TO: Dr. Jesse Bacon
FROM: Bret Highley
DATE: October 12, 2021
RE: Tier 1 800 Student Elementary School BG 20-142
Change Order 08

Change Order

REQUEST FOR PROPOSAL

PROJECT:	OLD MILL ELEMENTARY SCHOOL 199 Golden Wing Road Mt Washington, Kentucky 40047	REQUEST FOR PROPOSAL NO.:	11
OWNER:	Bullitt County Public Schools 1040 Highway 44 East Shepherdsville, KY 40165	DATE:	4-Oct-2021
TO CONTRACTOR:	Redlee Construction & Development 800 Stonecreek Pkwy, Suite 5A Louisville, KY 40223	ARCHITECT:	Studio Kremer Architects 1231 S Shelby Street Louisville, KY 40203
		ARCHITECT'S PROJECT NO.:	2019-50 BG# 20-142

ASK-29.1

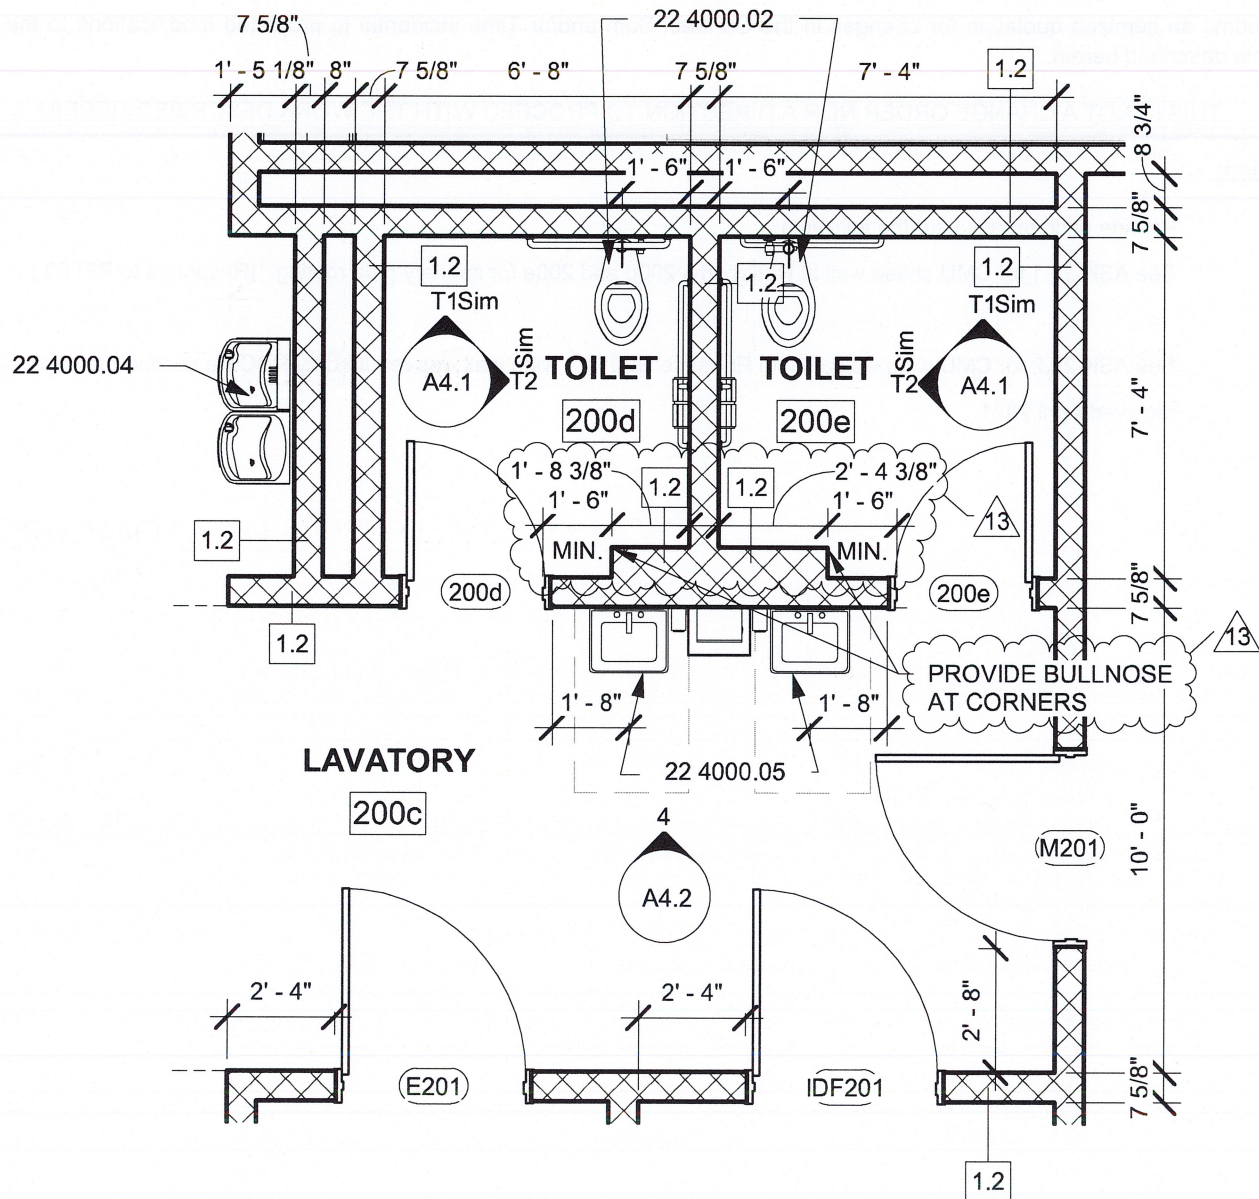
This Change Order has two parts. The first is adding a block chase wall at the Restrooms 200d and 200e in area D the Preschool and First grade hallway. This chase wall must be added to the project to allow the domestic water and vent piping to miss the floor trusses above the proposed restroom wall. The second part of this Change Order is to build a 2'x 4' block wall in the gym as required by HBC for ADA accessibility.

The need for chase walls at two single occupant restrooms what due to a conflict where the floor joist is located directly below the wall where sanitary piping needed to run to serve the hallway sinks. Without the chase, piping would be exposed in an area occupied by students and staff. The chase size was kept at a minimum to reduce the need for extra materials and labor. This condition occurs in the Area D restroom area.

- Item 1:** See ASK-29.1 for CMU chase wall at Restrooms 200d and 200e for sanitary pipe routing. (Response to RFI 50.)
- Item 2:** See ASK-29.2 for CMU wing wall at Gym Entrance G001.1 - wing wall was required by HBC via second plan review received April 2021.

ASK-29.2

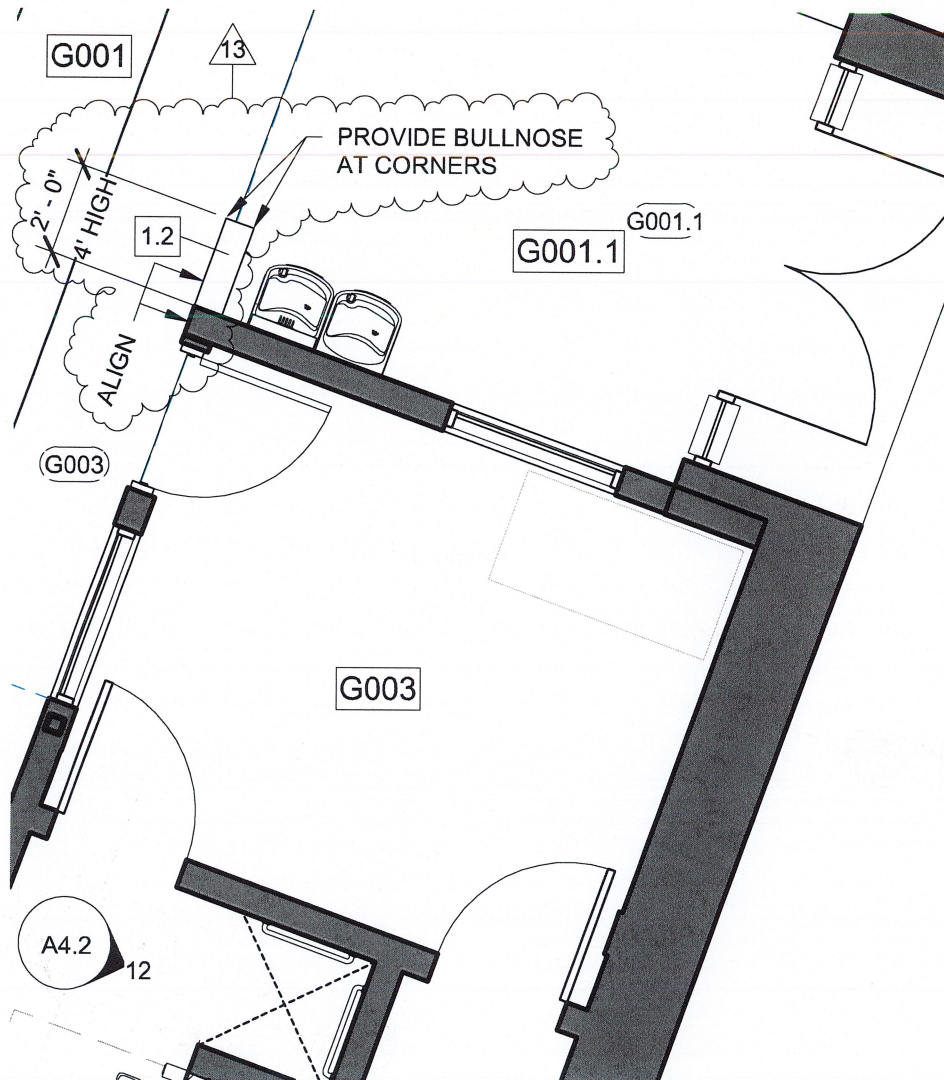
The water fountain wing wall was a code enforcement requirement noted in the revised plan review received April 2021. The reason for the wall is to alert a visually impaired person to the presence of the water fountain that projects into a path of travel to an exit off the Gym. The wing wall was kept to the minimum size required by code and approved by the code enforcement official.
